8702020558 870123  
PDR ADOCK 05000528  
P

SHUTDOWN MARGIN -  $K_{N-1}$  - ANY CEA WITHDRAWN

SHUTDOWN MARGIN VERSUS COLD LEG TEMPERATURE

FIGURE 3.1 - 1A

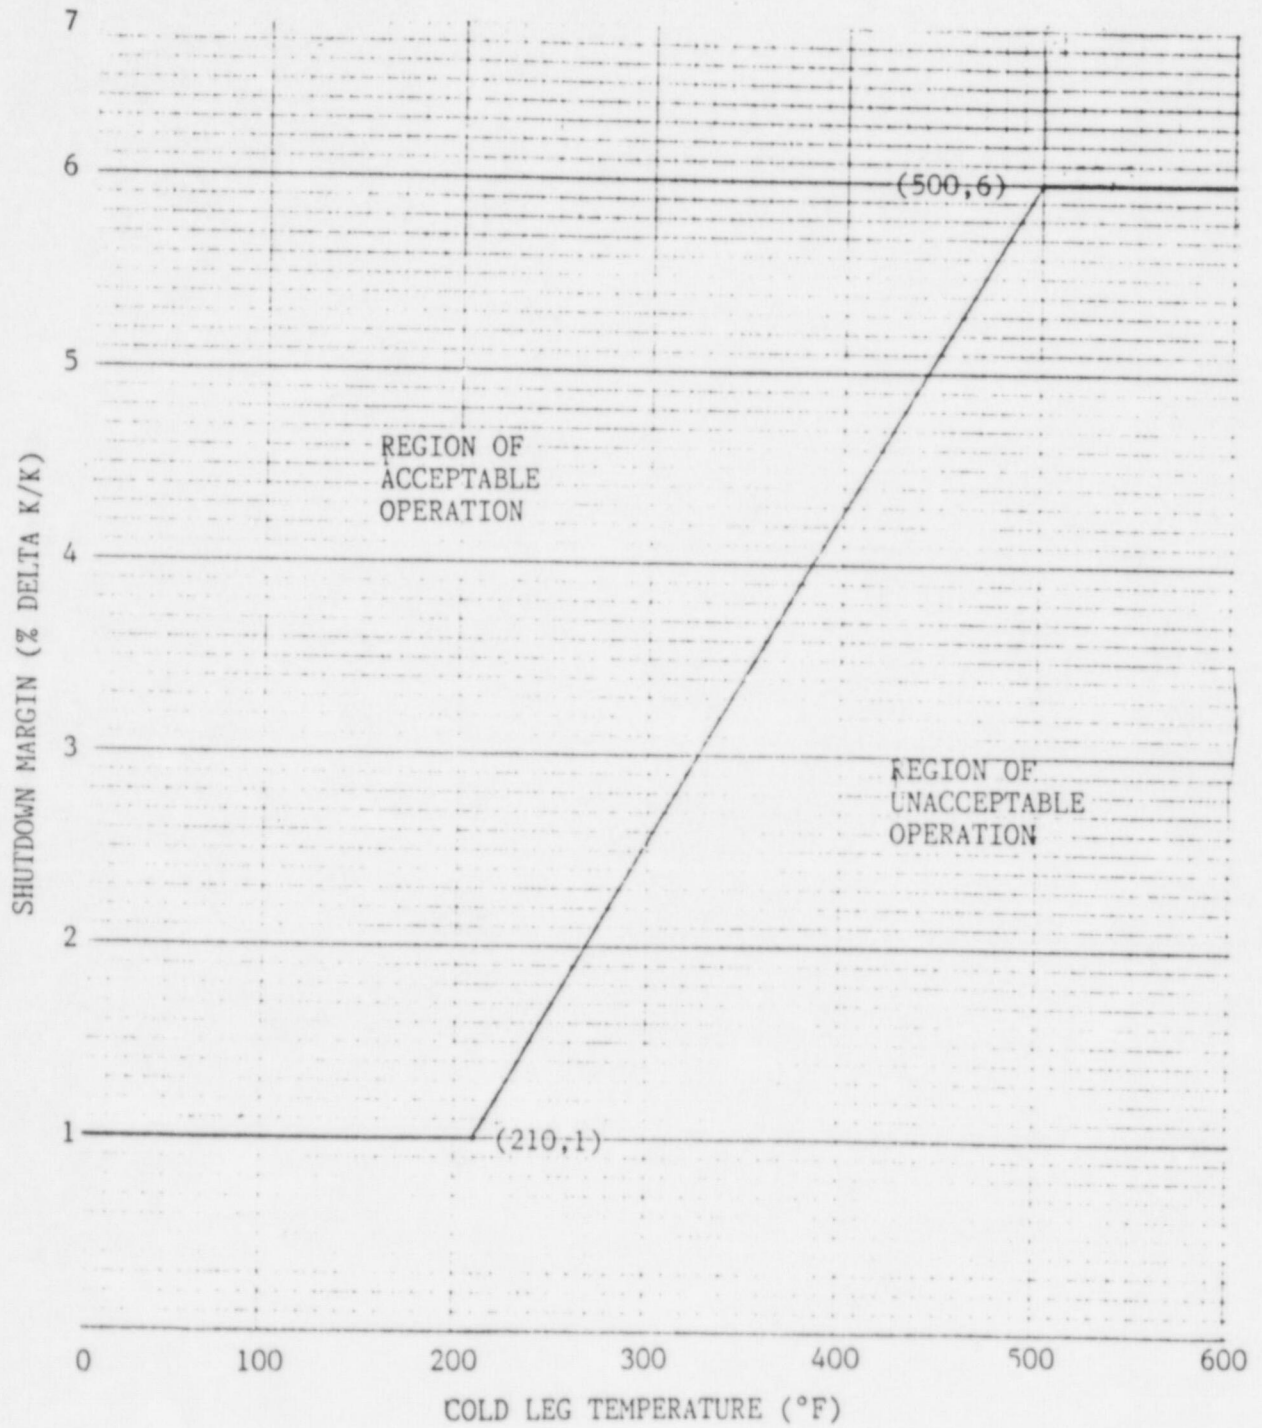
- a. The SHUTDOWN MARGIN shall be greater than or equal to that shown in Figure 3.1-1A, and
- b. For  $T_{cold}$  less than or equal to 500 °F,  $K_{N-1}$  shall be less than 0.99.

- a. With the SHUTDOWN MARGIN less than that in Figure 3.1-1A, immediately initiate and continue boration at greater than or equal to 26 gpm to the reactor coolant system of a solution containing greater than or equal to 4000 ppm of boron or equivalent until the required SHUTDOWN MARGIN is restored, and
- b. With  $T_{cold}$  less than or equal to 500 °F and  $K_{N-1}$  greater than or equal to 0.99, immediately vary CEA positions and/or initiate and continue boration at greater than or equal to 26 gpm to the reactor coolant system of a solution containing greater than or equal to 4000 ppm of boron or equivalent until the required  $K_{N-1}$  is restored.

- 4.1.1.2.1 With any full-length CEA fully or partially withdrawn, the SHUTDOWN MARGIN shall be determined to be greater than or equal to that in Figure 3.1.1A:
  - a. Within 1 hour after detection of an inoperable CEA(s) and at least once per 12 hours thereafter while the CEA(s) is inoperable. If the inoperable CEA is immovable as a result of excessive friction or mechanical interference or known to be untrippable, the above required SHUTDOWN MARGIN shall be increased by an amount at least equal to the withdrawn worth of the immovable or untrippable CEA(s).

FIGURE 3.1 - 1A

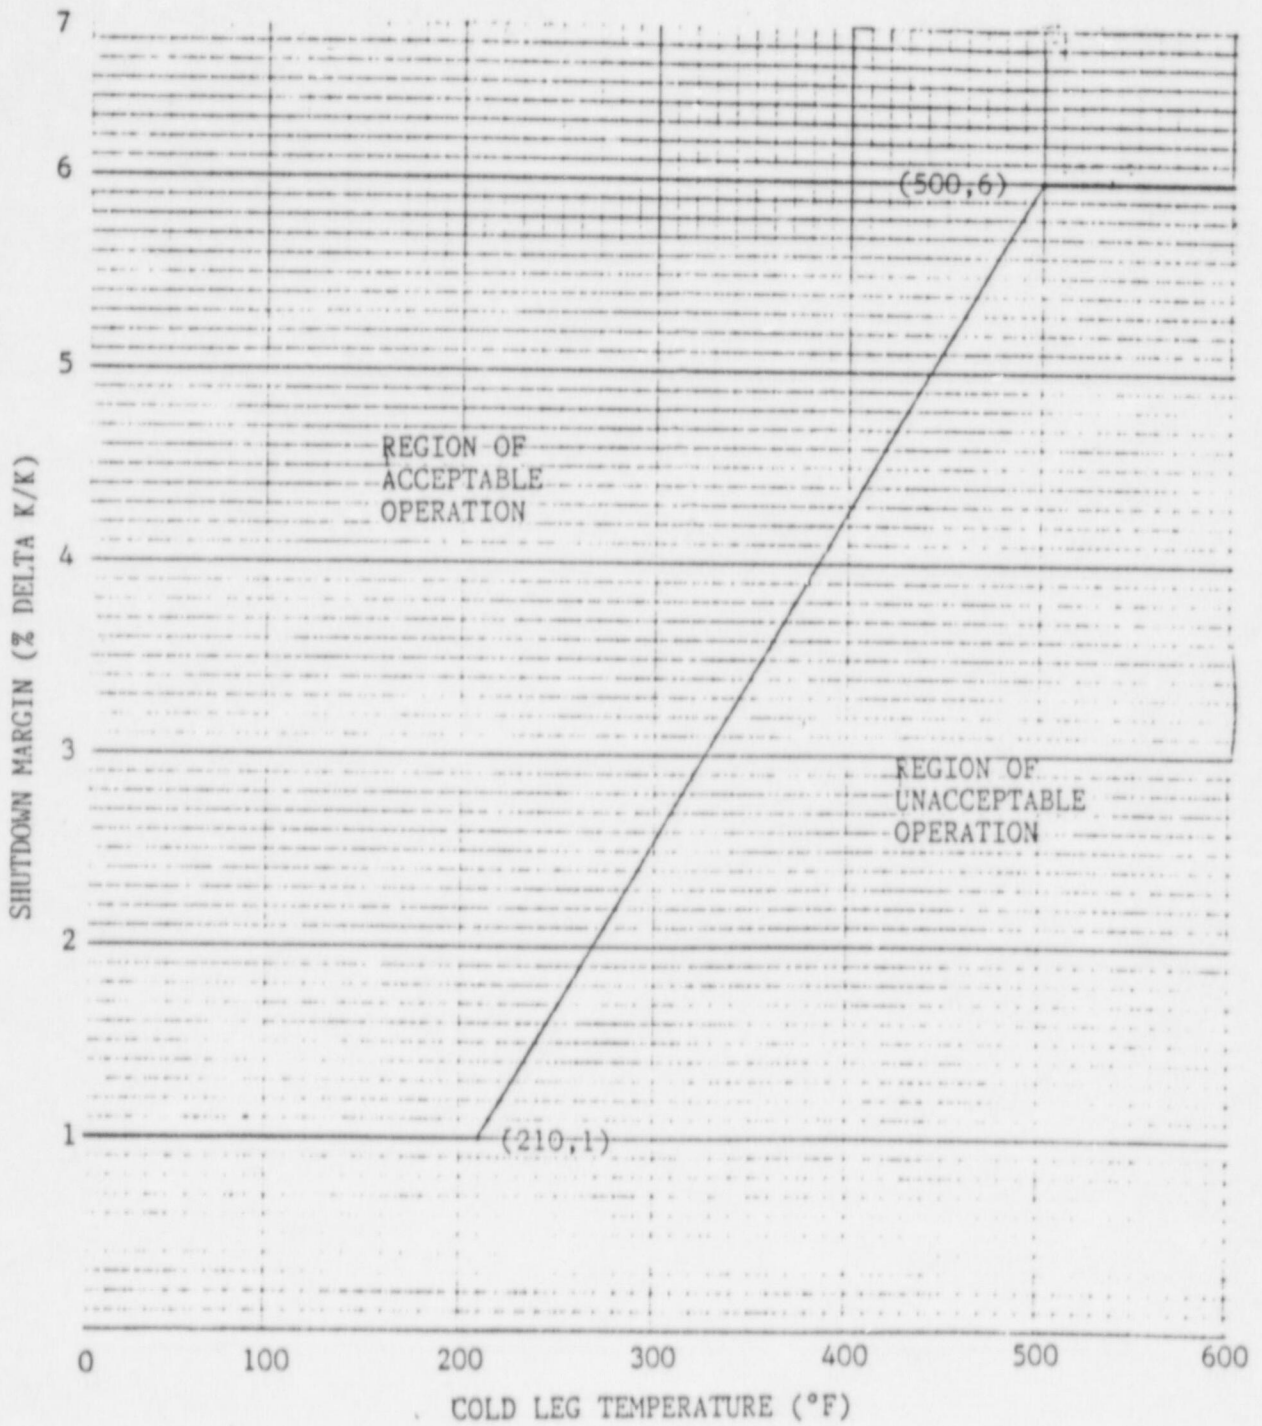
- a. The SHUTDOWN MARGIN shall be greater than or equal to that shown in Figure 3.1-1A, and
- b. For  $T_{cold}$  less than or equal to 500 °F,  $K_{N-1}$  shall be less than 0.99.

- a. With the SHUTDOWN MARGIN less than that in Figure 3.1-1A, immediately initiate and continue boration at greater than or equal to 26 gpm to the reactor coolant system of a solution containing greater than or equal to 4000 ppm of boron or equivalent until the required SHUTDOWN MARGIN is restored, and
- b. With  $T_{cold}$  less than or equal to 500 °F and  $K_{N-1}$  greater than or equal to 0.99, immediately vary CEA positions and/or initiate and continue boration at greater than or equal to 26 gpm to the reactor coolant system of a solution containing greater than or equal to 4000 ppm of boron or equivalent until the required  $K_{N-1}$  is restored.

- 4.1.1.2.1 With any full-length CEA fully or partially withdrawn, the SHUTDOWN MARGIN shall be determined to be greater than or equal to that in Figure 3.1.1A:
  - a. Within 1 hour after detection of an inoperable CEA(s) and at least once per 12 hours thereafter while the CEA(s) is inoperable. If the inoperable CEA is immovable as a result of excessive friction or mechanical interference or known to be untrippable, the above required SHUTDOWN MARGIN shall be increased by an amount at least equal to the withdrawn worth of the immovable or untrippable CEA(s).
